SUDAS Revision Submittal Form

Status Date:	As of 11/2/2026	**Topic:**	Class A sidewalk
Manual:	Specifications	**Manual Location:**	Figures 7030.201 and 7030.202

FIGURE 7030.201 | SHEET 1 OF 1

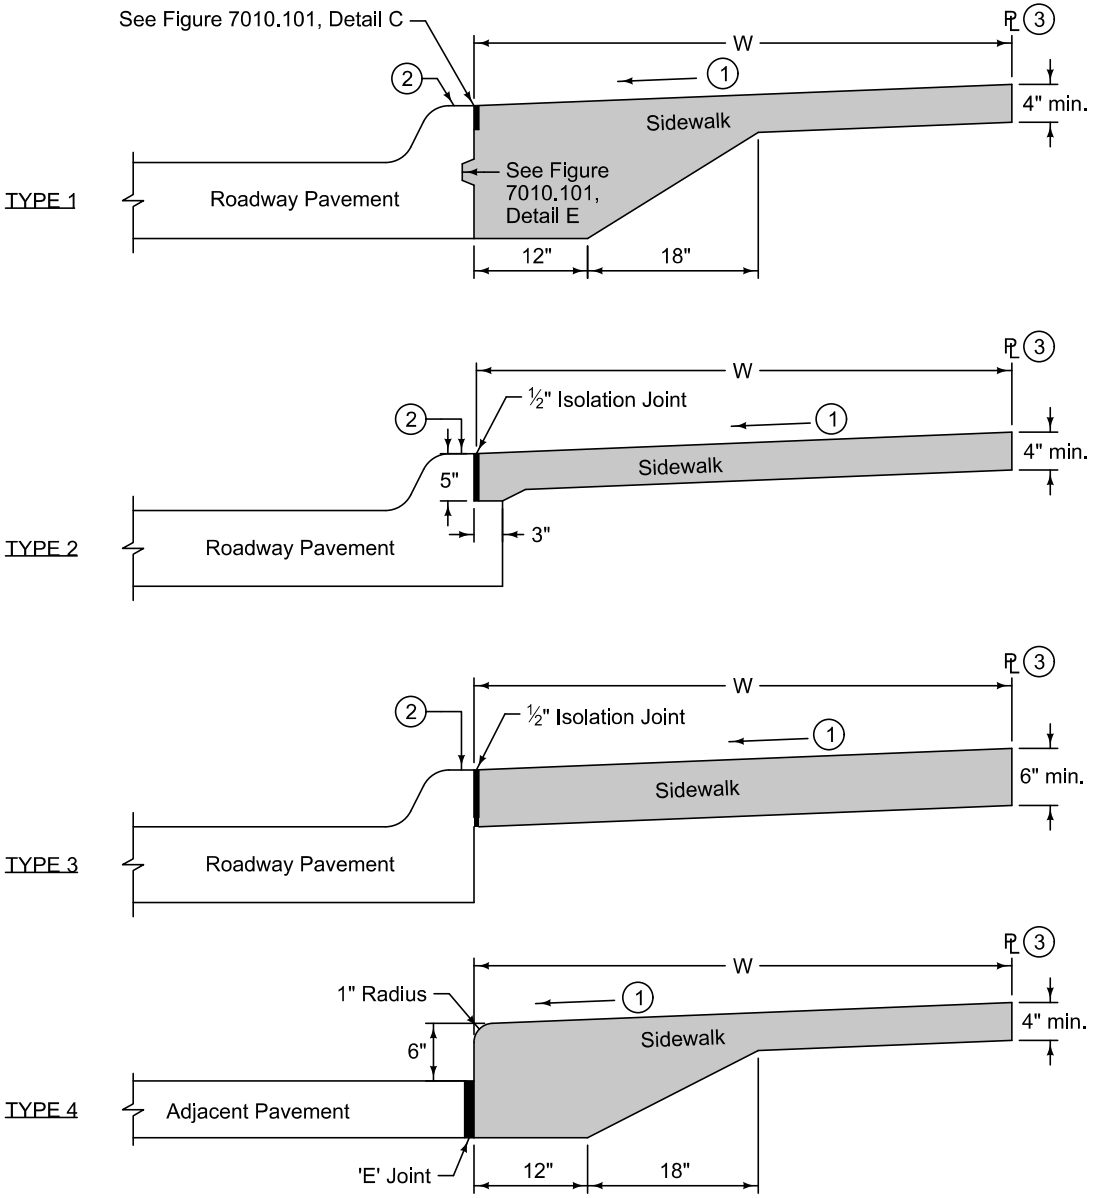
Requested Revision: *See attached.*

Reason for Revision: Including an additional sidewalk option.

Region:	☒ Central	☐ East	☐ West
Comments:	Okay with adding new 6 inch option (need to remove reference to Figure 7030.202), but leave the other cross-section; need to revise the bid item. Perhaps change the left detail to 6 inches thick.		
Action:	☒ Tabled	☐ Not Approved	☐ Approved
Region:	☐ Central	☒ East	☐ West
Comments:	Add a type 1 and type 2 to the two different Class A options; also clarify the Figure 7030.202 reference on the new detail		
Action:	☐ Deferred	☐ Not Approved	☒ Approved
Region:	☐ Central	☐ East	☒ West
Comments:	For the original Class A detail, increase the sidewalk thickness to 6 inches; clarify reference to Figure 7030.202; add a type 1 and type 2		
Action:	☐ Deferred	☐ Not Approved	☒ Approved

Final Regional Action Summary: Only 2 of the regions approved; see comments above. *Note - after discussions at all regions, staff developed shifted all of the Class A sidewalk details to Figure 7030.201 and Class B and C sidewalks to Figure 7030.202.*

For new sidewalk with new curb and gutter, comply with Type 1, 2, or 3. For new sidewalk adjacent to existing pavement, comly with Type 3 or 4, or when specified in the contract documents.
